SERVICE BULLETIN REVISION NOTICE

ENGINE — SEAL ASSEMBLY, NO. 4 BRG FRONT AND HOUSING ASSEMBLY, NO. 4 BRG OIL NOZZLE BLOCK AND NO. 4 BRG OIL NOZZLE ASSEMBLY — REPLACE OR MODIFY TO STOP OIL NOZZLE BLOCK HOUSING BOLTS FROM LIBERATION

Turbojet Engine Service Bulletin No. V2500-ENG-72-0629 Revision No. 3 dated February 25, 2021.

Revision 3 dated February 25, 2021

LOCATION OF DIFFUSER AND COMBUSTOR GROUP AND NO. 4
BEARING FRONT SEAL ASSEMBLY
FIGURE 1, SHEET 1

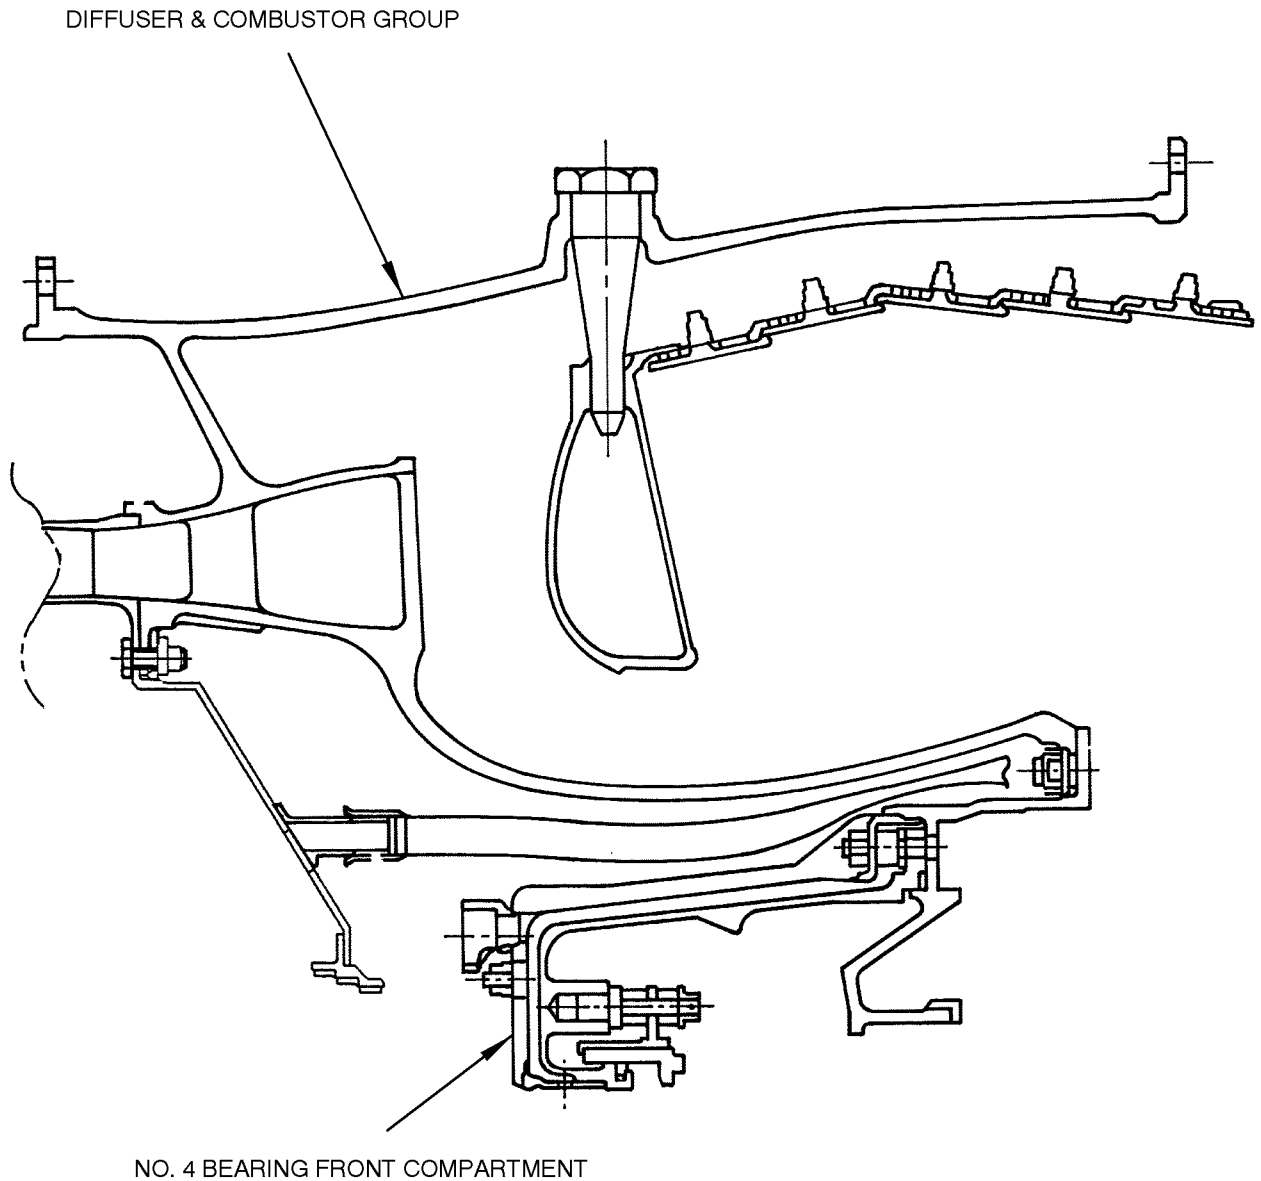
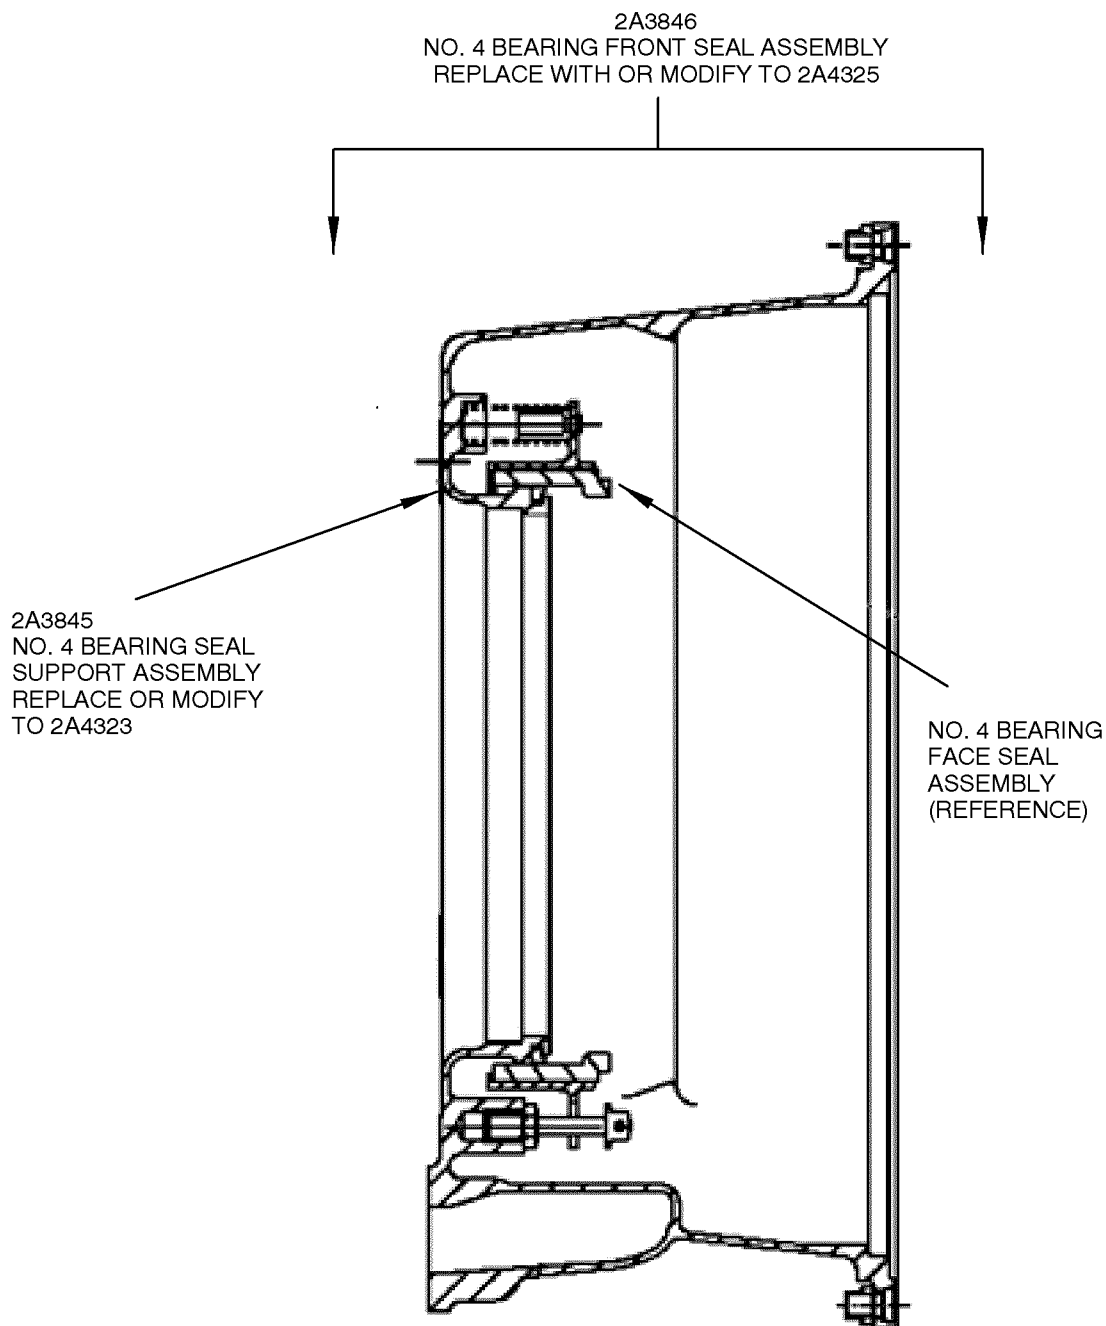
1. Replace the No. 4 Bearing Front Seal Assembly, PN 2A3846, with PN 2A4325, or modify the No. 4 Bearing Front Seal Assembly, PN 2A3846 by the procedure that follows: See Figure 1.

LOCATION OF NO. 4 BEARING OIL NOZZLE BLOCK HOUSING ASSEMBLY
72-42-34
FIGURE 2

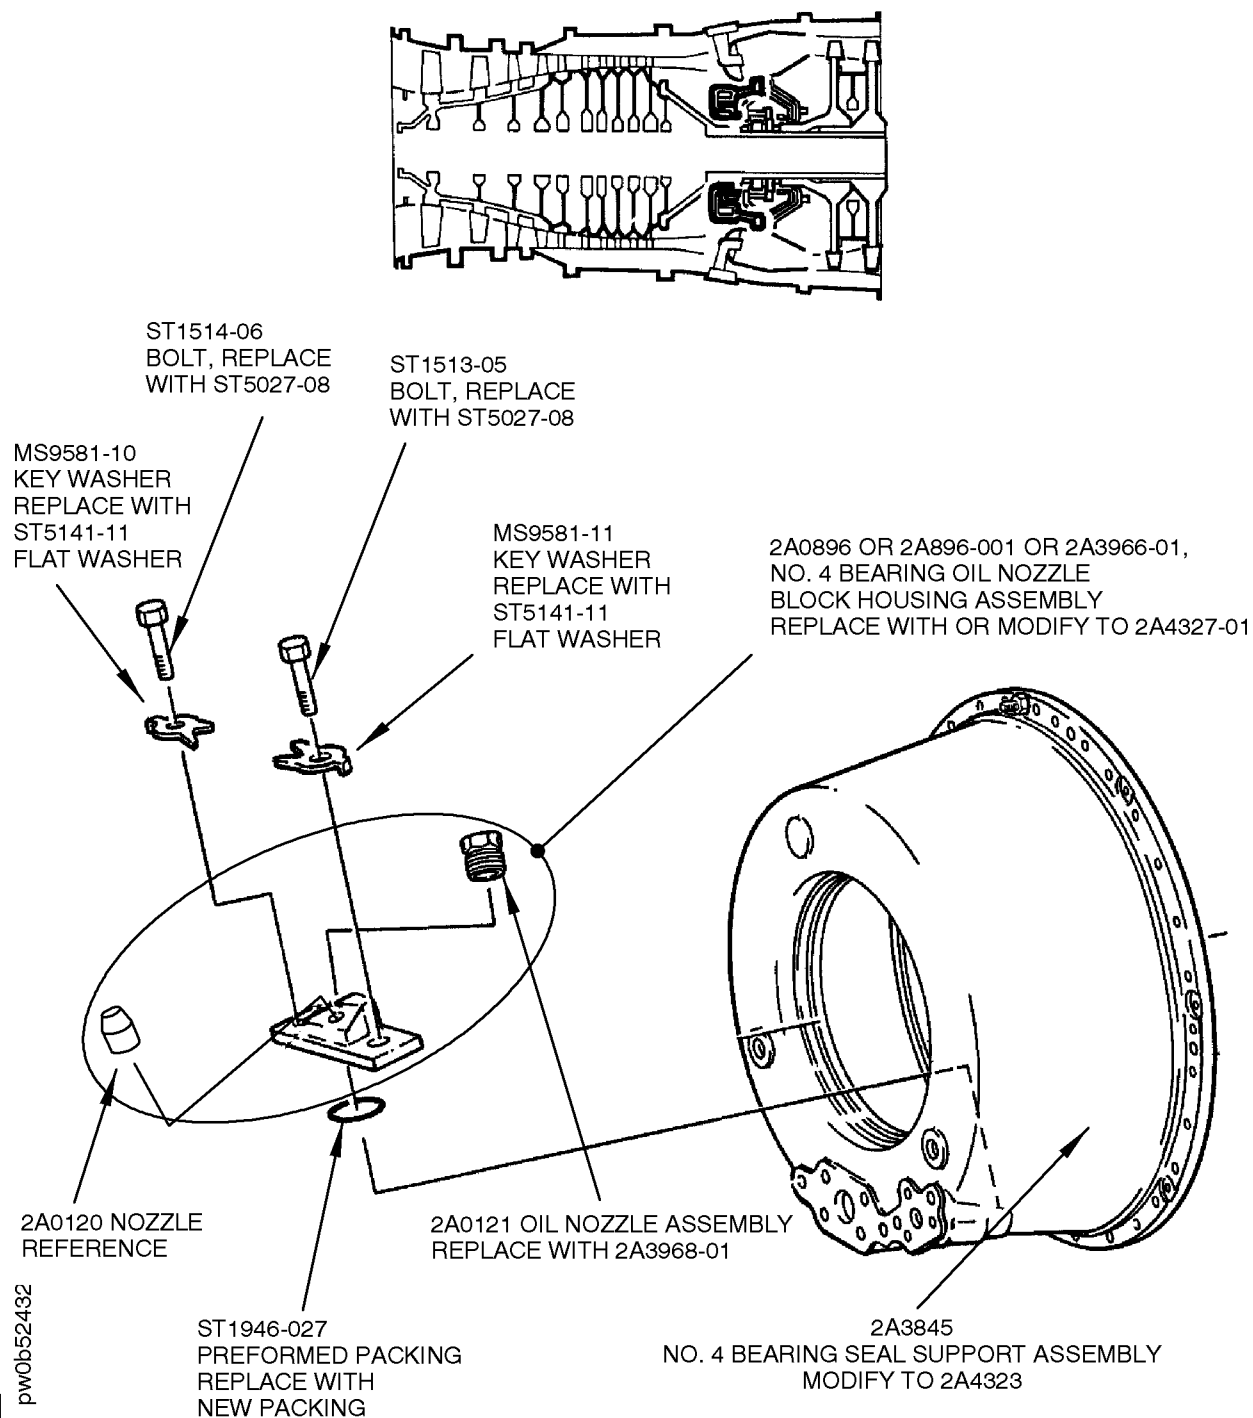
- A. Remove No. 4 Bearing Oil Nozzle Housing Block Assembly, PN 2A3966-01, PN 2A0896 or PN 2A0896-001 per Reference 7 or 8, Engine Manual, Chapter/Section TASK 72-42-30-040-001, Subtask 72-42-30-040-056. See Figure 2.

- D. Install two (2) Bolts, PN ST5027-08, and two (2) Flat Washers, PN ST5141-11, to secure the No. 4 bearing oil nozzle block housing assembly. See Figure 2.

MODIFICATION OF THE NO. 4 BEARING OIL NOZZLE BLOCK HOUSING ASSEMBLY,
 PN 2A3966-01, OR PN 2A0896, OR PN 2A0896-001
 FIGURE 4

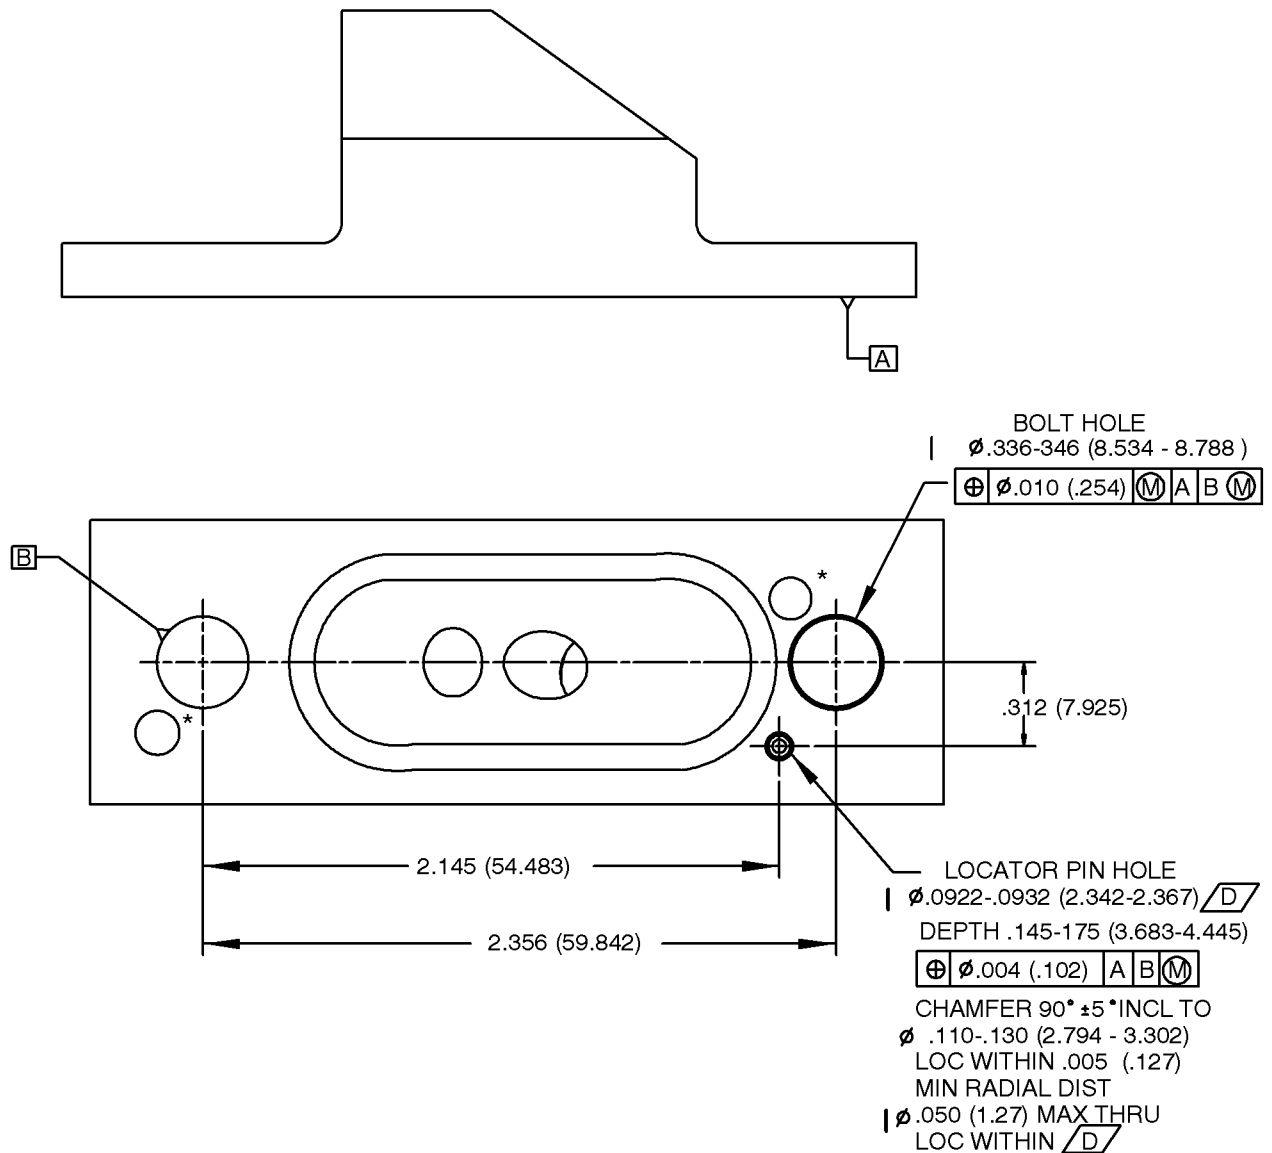
- A. Mask oil passages and the oil nozzle assembly and the No. 4 bearing oil nozzle block housing assembly to protect from machining debris.
 - B. Position No. 4 bearing oil nozzle block housing assembly such that oil nozzle points down. Datums and orientation are shown in Figure 4.

- C. Use an end mill to make a 0.336 – 0.346 inch (8.53 – 8.79 mm) diameter bolt hole as shown in Figure 4.
 - D. Machine a 0.09225 inch (2.343 mm) diameter stepped hole for a pin as shown in Figure 4.

LOCATION OF INSTALLED LOCATOR PIN IN THE NO. 4 BEARING OIL
NOZZLE BLOCK HOUSING ASSEMBLY
FIGURE 5

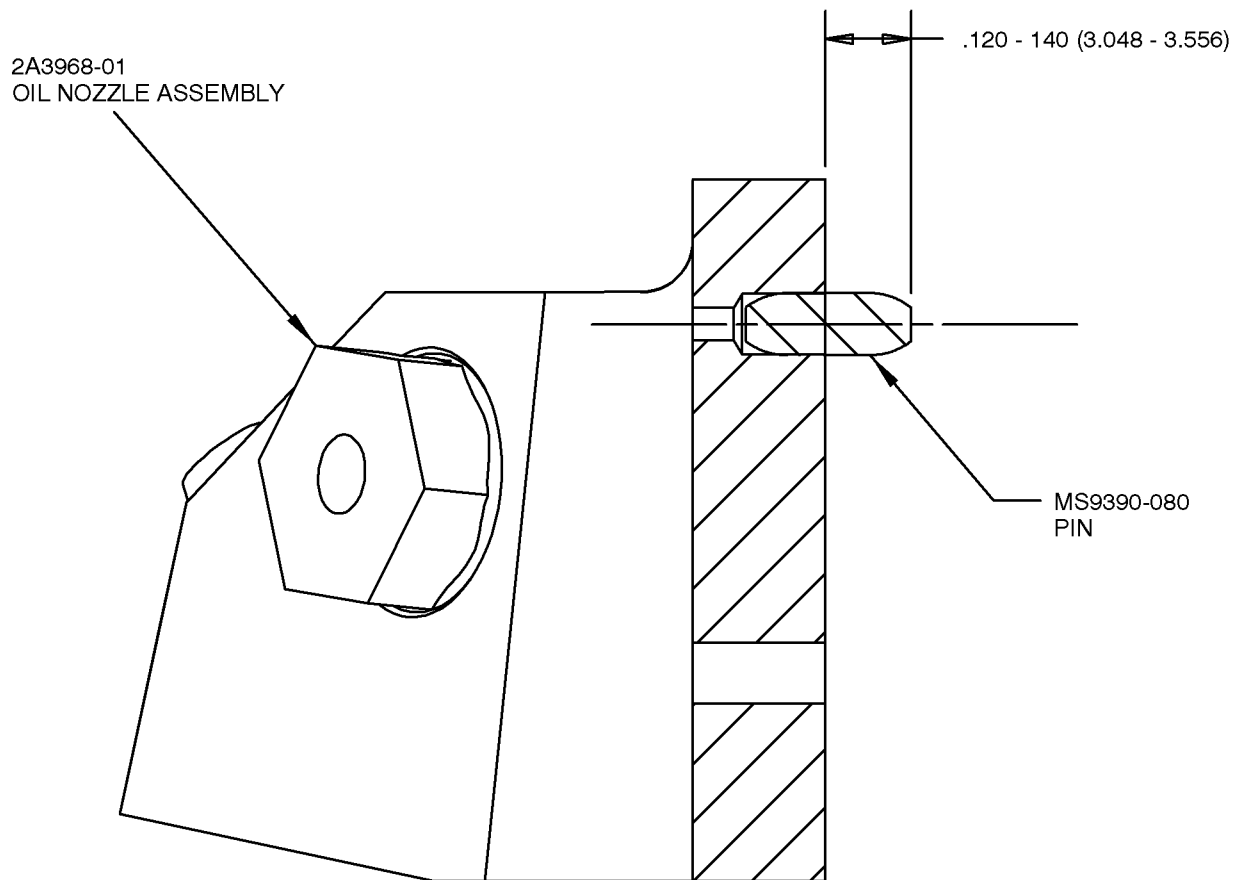
- H. Press the Pin, PN MS9390-080, into the No. 4 bearing oil nozzle block housing assembly so that the pin protrudes 0.120 – 0.140 inch (3.05 – 3.56 mm) above Datum A as shown in Figure 5.

NO. 4 BEARING SEAL SUPPORT ASSEMBLY OIL NOZZLE BOSS
FIGURE 6

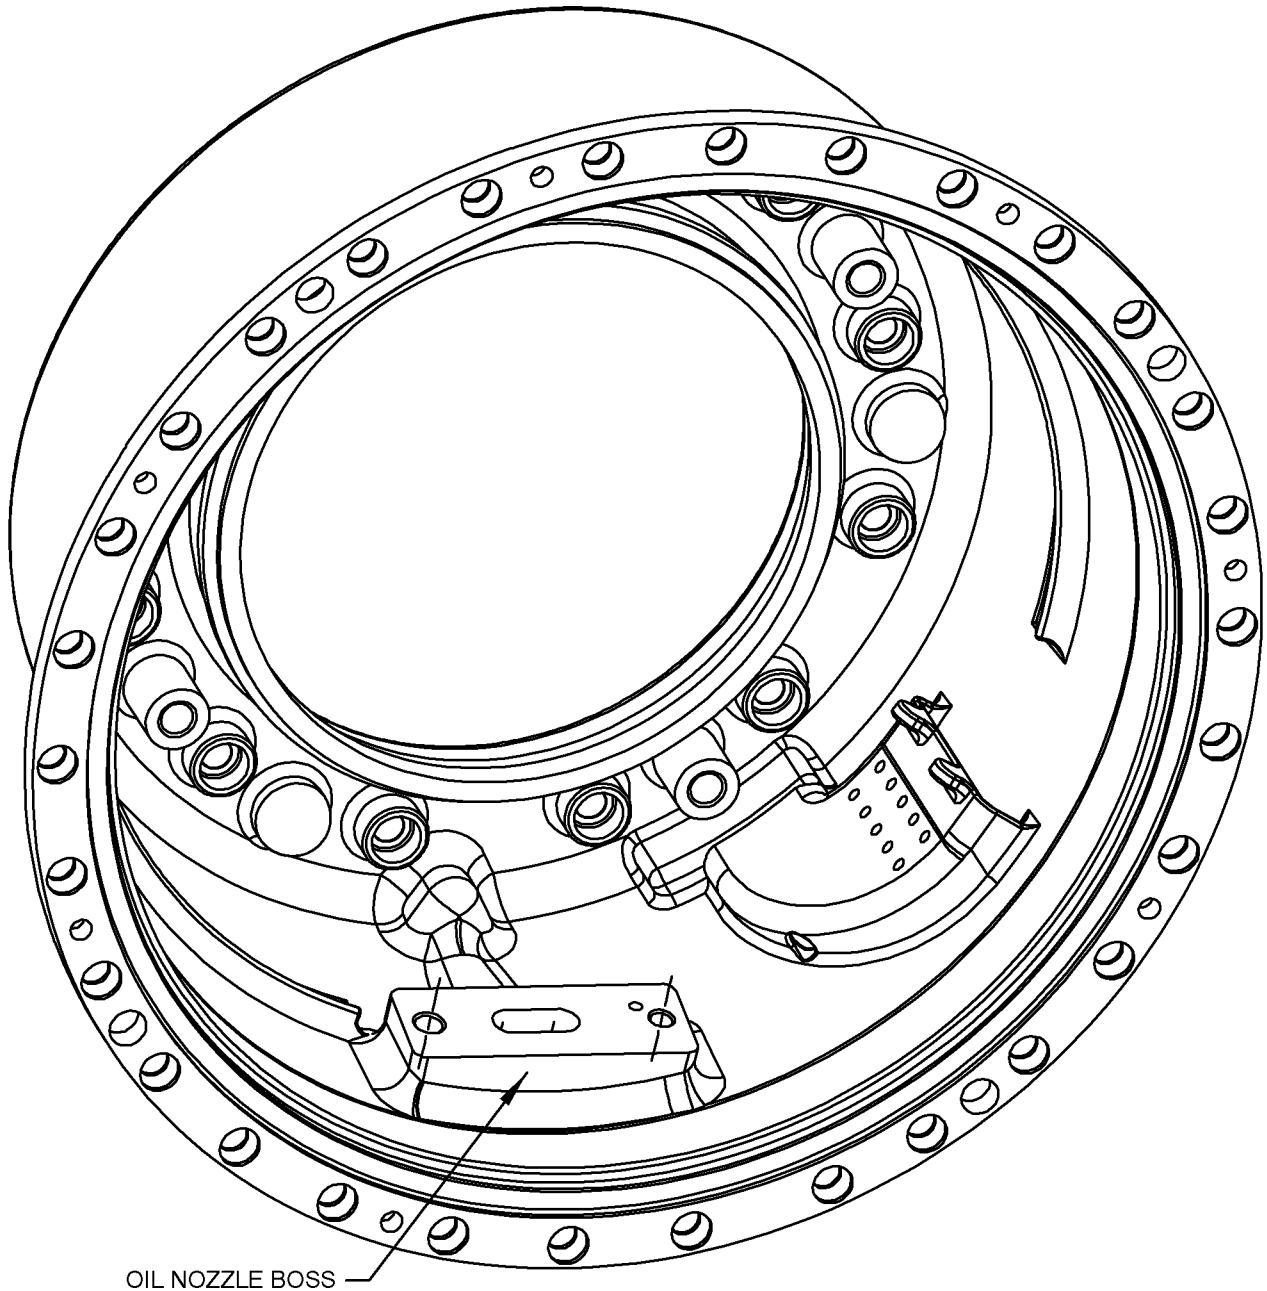
- (2) Position No. 4 Bearing Support Seal Assembly, so that the oil nozzle boss is easily accessible. Datums and orientation are shown in Figures 6 and 7.
